ITS: 5909	
SECTION:	231 Coolant System
WRITTEN BY:	Mike Pearson
SUBJECT:	Add EMP Radiator Ground Straps

# ITS5909

## Bulletin Overview

Figure 1: Mini-Hybrid® Cooling Systems

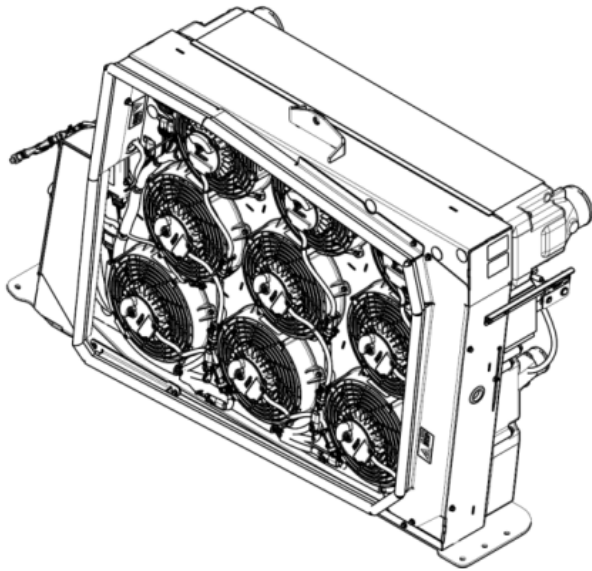
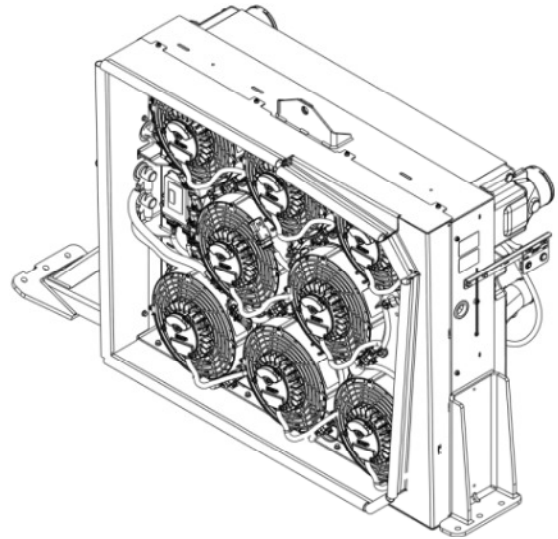
Voltage potential between radiator and coolant pipes can be eliminated by grounding the Mini-Hybrid® cooling system and coolant pipes to the vehicle chassis.

**Note: If experiencing accelerated radiator corrosion, the work described in this bulletin must be completed in order to maintain your 3 year EMP radiator warranty coverage. Failure to act promptly may affect coverage for accelerated corrosion through the radiator due to stray current.**

**Figure 4: Existing Rear Corner Support Angle**

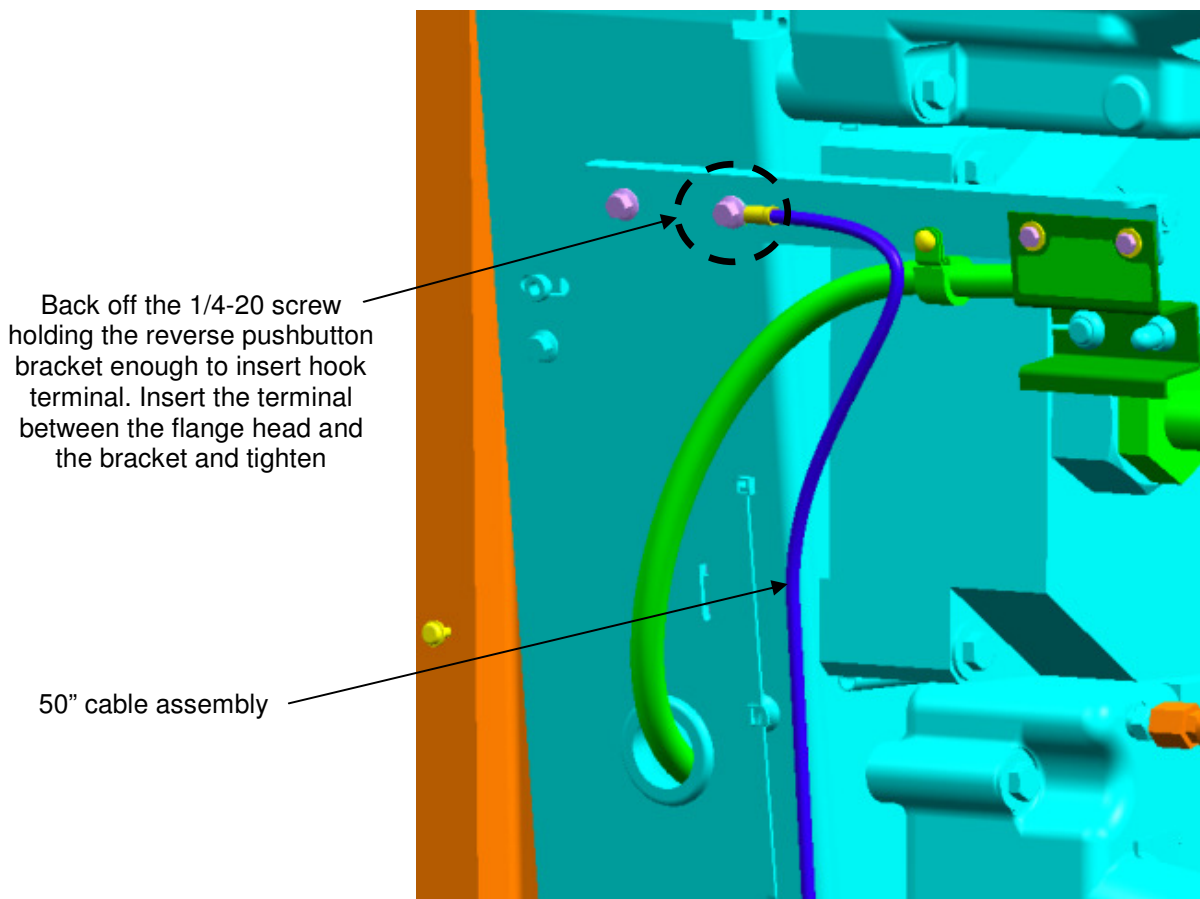
4. To ground Mini-Hybrid® cooling system shroud, back off the 1/4-20 screw holding the reverse pushbutton bracket enough to insert provided hook terminal from 50" cable. Insert the terminal between the flange head and the bracket. There is no need to scrape any powder off the Mini-Hybrid® system shroud as a good ground is achieved through the PEM nut in the shroud. Torque to  $12 \pm 2$  ft-lbs.
5. Route ground wire to area approximately 4.5" forward of the welded rail (see Figure 7), routing wire away from any hot surfaces or sharp edges. Use zip ties to secure wire at 18-24" intervals. Adjust cable orientation if necessary. Proceed with grounding of radiator tubes before securing shroud ground wire.

**CAUTION: Grounding to the same welded assembly is required. Grounding to a bolted assembly is NOT acceptable.**

**Figure 5: Radiator and Upper Coolant Tube Ground Strap Installation**

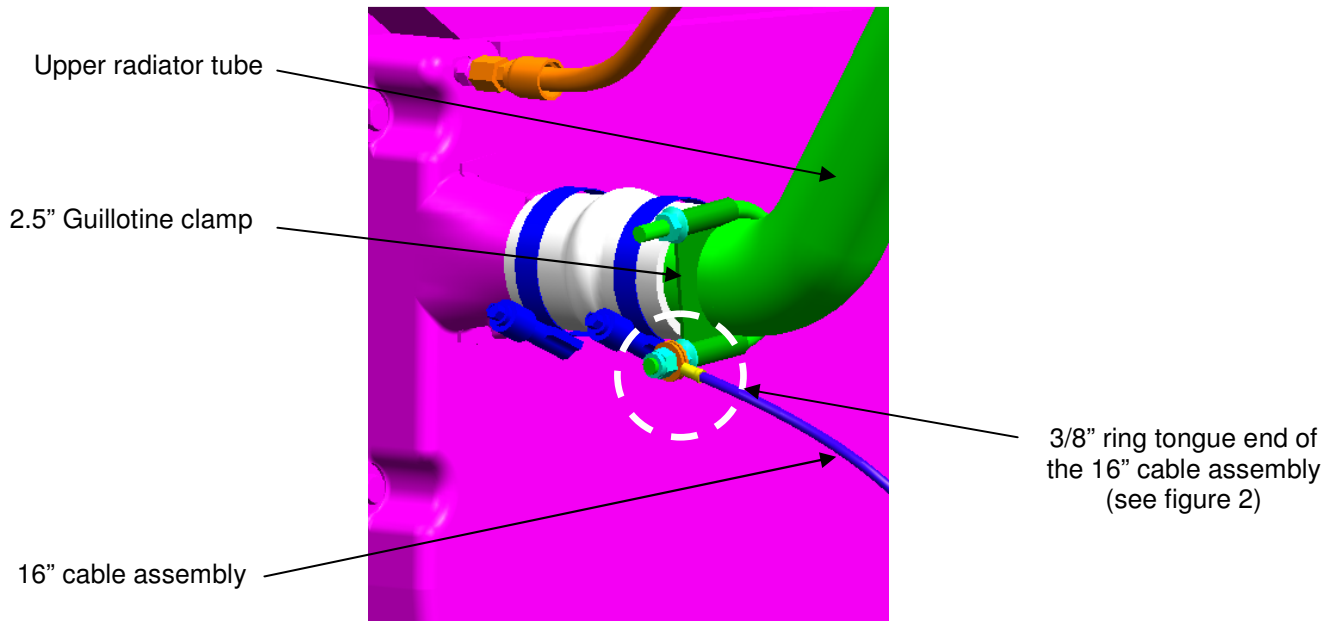
6. Install one of the 2.5" guillotine clamps from the parts kit to the existing upper radiator tube at the approximate location and orientation shown in Figure 5, torque to  $20 \pm 2$  ft\*lbs.
7. Attach the 3/8" ring tongue end of the 16" cable to the bottom stud of the guillotine clamp. Secure and orient the hardware as shown in Figure 3. Torque the hardware to  $20 \pm 2$  ft\*lbs.
8. Route ground wire to area approximately 4.5" forward of the welded rail (see Figure 7), routing wire away from any hot surfaces or sharp edges. Adjust clamp locations on coolant pipes if necessary.

**Figure 6: Lower Coolant Tube Ground Strap**

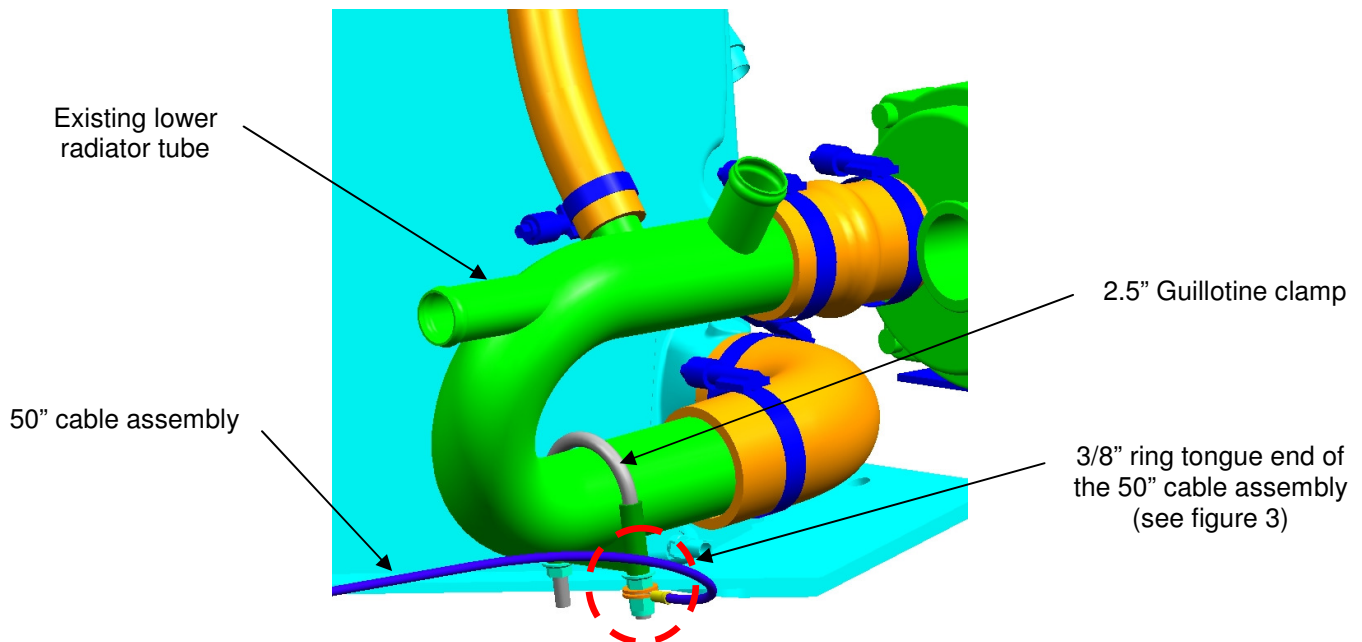
9. Install one of the 2.5" guillotine clamps from the parts kit to the existing lower radiator tube at the approximate location and orientation shown in Figure 6, torque to  $20 \pm 2$  ft\*lbs.
10. Attach the 3/8" ring tongue end of the 50" cable to the curb side stud of the clamp. Secure using the hardware supplied with the clamp. Secure and orientate as shown in Figure 3. Torque the hardware to  $20 \pm 2$  ft\*lbs. Route the other end of the cable to the rear of the street side engine rail. See Figure 7.
